Response to DSD's comments (Application No. A/NE-FTA/239)

**Proposed Temporary Vehicle Repair Workshop for Private Car for a Period of 3 Years
at Lot 143 (Part) in D.D. 52 & Adjoining Government Land, Sheung Shui, New Territories**

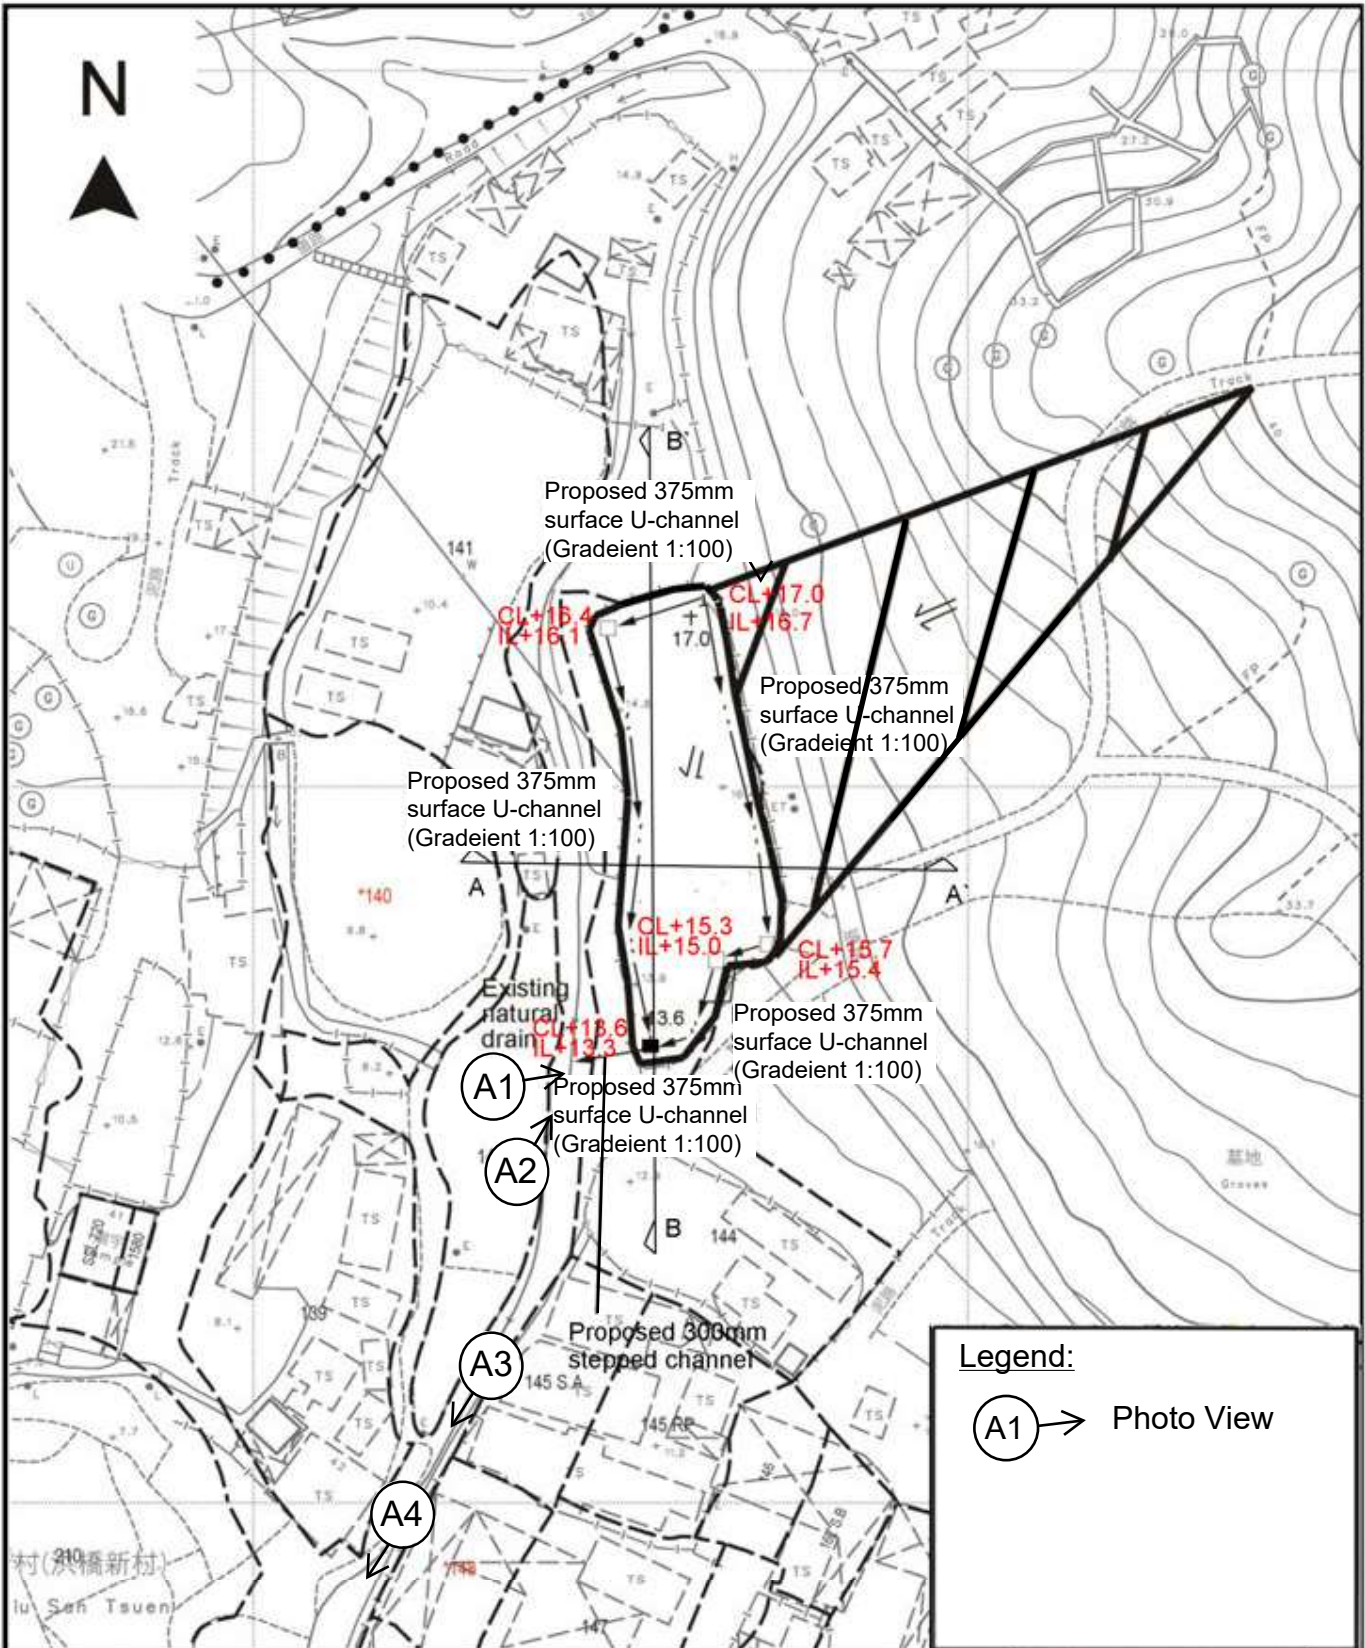
| <p>2. My previous comment regarding the clearance between the proposed site hoarding and the existing streamcourse was NOT responded, please clarify.</p> | <p>Please see the enclosed photo Plate A1 shown the distance between the proposed site hoarding and the existing streamcourse is around 200mm.</p> |

Figure 8.7 - Chart for the Rapid Design of Channels

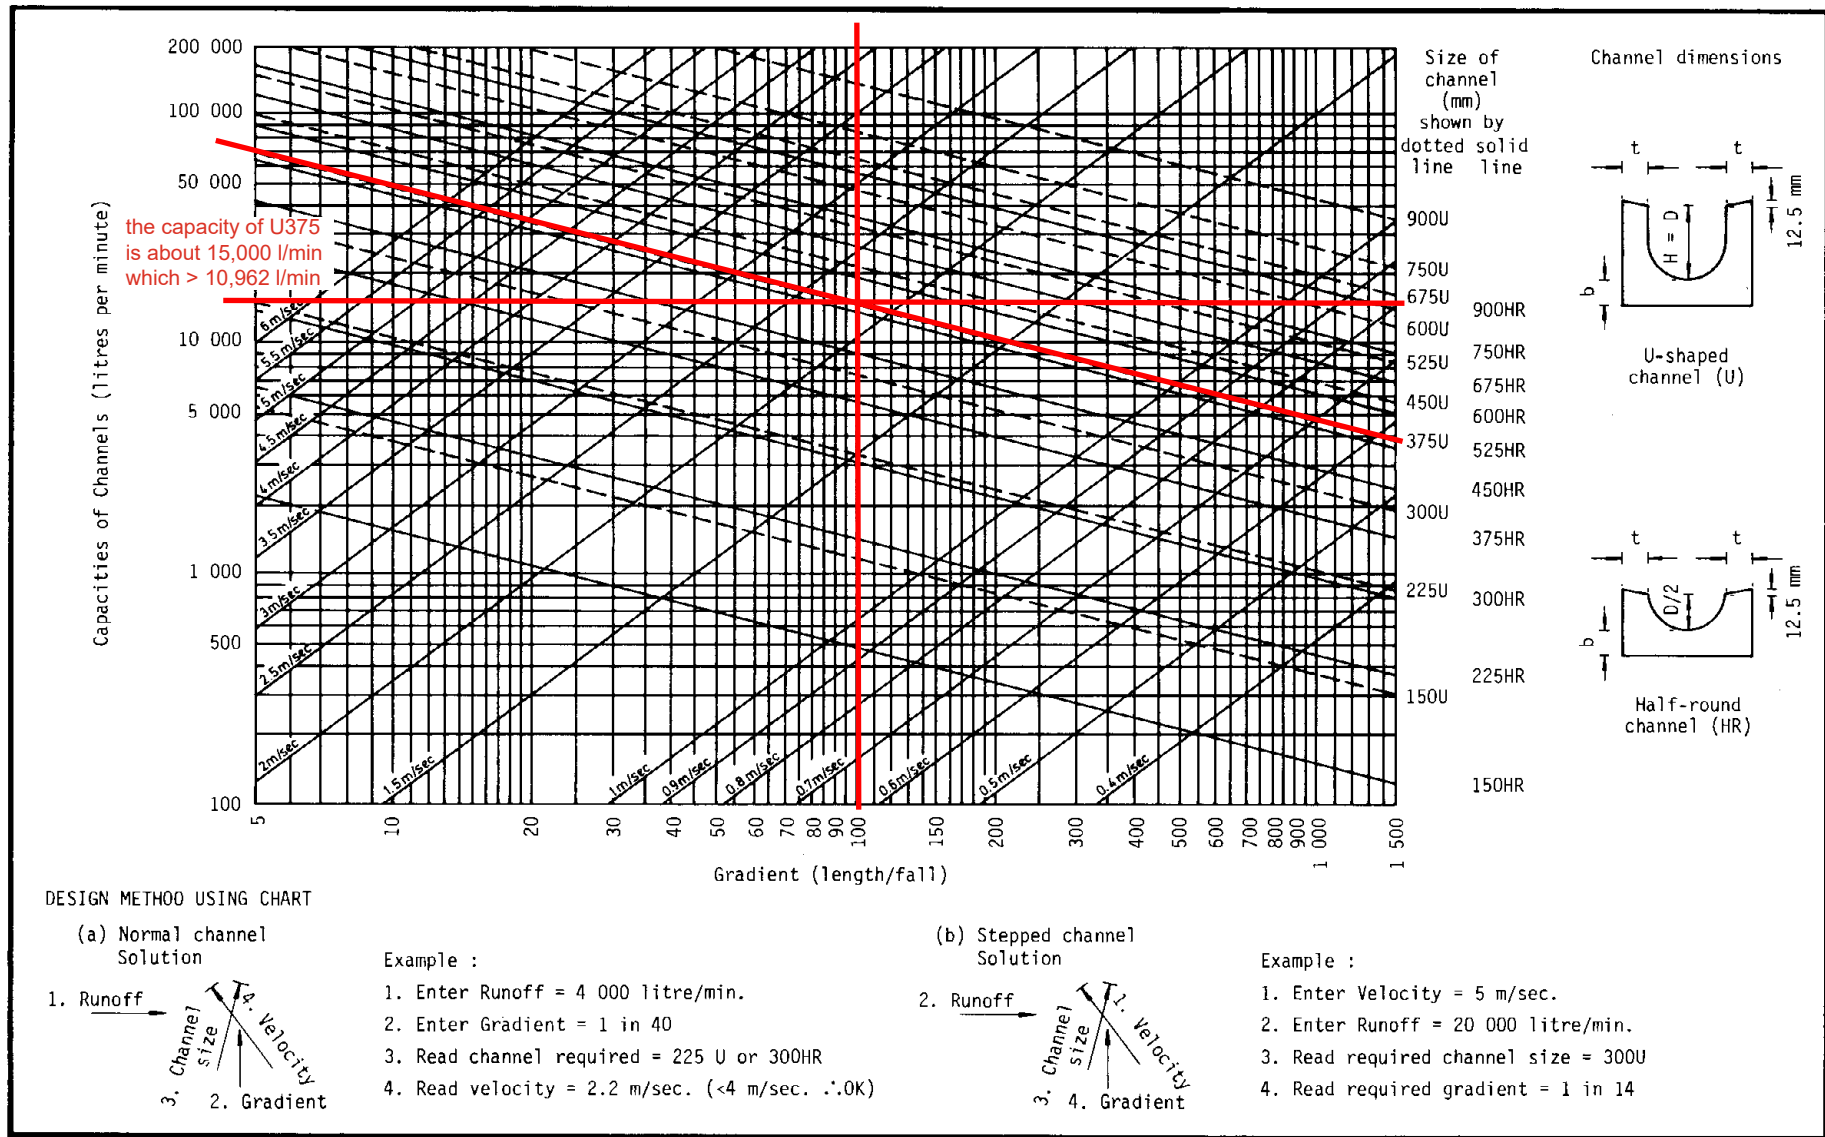
| <p>3. Please validate if 1:22 gradient U-channel can be practically implemented on site. Please advise the utilization of the proposed 300mm U-channel.</p> | <p>Refer to the drainage design submitted before, the surface is 10,962 l/min. In accordance with the Chart or the Rapid Design of Channels in "Geotechnical Manual for Slopes", 375mm surface U-channel in 1:100 gradient will be adopted to replace 300mm U-channel in 1:22 gradient, please see the enclosed Figure B and revised Figure A</p> |
